Access Compliance Report

Public Rights-of-Way

(Curb Ramps)

Intersection ID: 30034	Main Street: DAY_LILLY_LN	Cross Street: SUMMER_COACH_DR	Location: SE
ADA ID: 2713BC9EA851	Ramp Type: PerpDiag	Initial Pass/Fail: Fail	Overall Compliance: No
Codes/Mitigation Info/Possible Solution		Field Measurements/Component Compliance

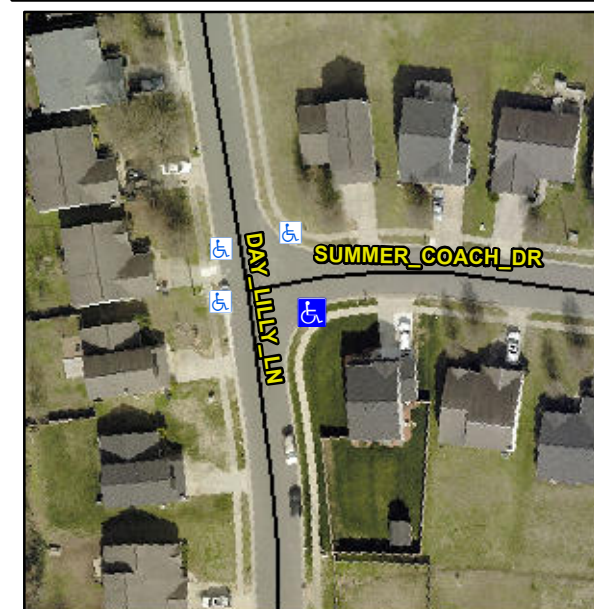
Not Found, R304.2.2, R304.5.3

Compliance	Description	Data	Compliance	Description	Data
N/A	Ramp Length (in)	47.5	No	Ramp Slope (%)	10.4
Yes	Ramp Width (in)	48.0	No	Ramp XSlope (%)	2.6
N/A	Flare Type LT	N/A	N/A	Flare Type RT	N/A
N/A	Flare Slope LT (%)	N/A	N/A	Flare Slope RT (%)	N/A
N/A	Flare Traversable LT?	N/A	N/A	Flare Traversable RT?	N/A
N/A	Landing Length (in)	N/A	N/A	DWS Provided?	N/A
N/A	Landing Width (in)	N/A	N/A	DWS Contrast?	N/A
N/A	Landing Slope (%)	N/A	N/A	DWS Length (in)	N/A
N/A	Landing X Slope (%)	N/A	N/A	DWS Full Width?	N/A
N/A	Landing Curb? (Y/N)	N/A	N/A	DWS Offset (in)	N/A
N/A	Shared Landing?	N/A			
N/A	Gutter Ponding?	N/A	N/A	Gutter Slope (%)	N/A
N/A	Gutter Lip Ht (in)	N/A	N/A	Gutter X Slope (%)	N/A
N/A	Painted X Walk1?	No	N/A	Painted X Walk2?	No
	X Walk 1 Direction	To N		X Walk 2 Direction	To NW
N/A	X Walk 1 Width (in)	N/A	N/A	X Walk 2 Width (in)	N/A
	X Walk 1 Slope (%)	0.4		X Walk 2 Slope (%)	0.1
	X Walk 1 X Slope (%)	1.0		X Walk 2 X Slope (%)	1.9

Remove & Replace Curb Ramp With Two New Directional Ramps or Equivalent.
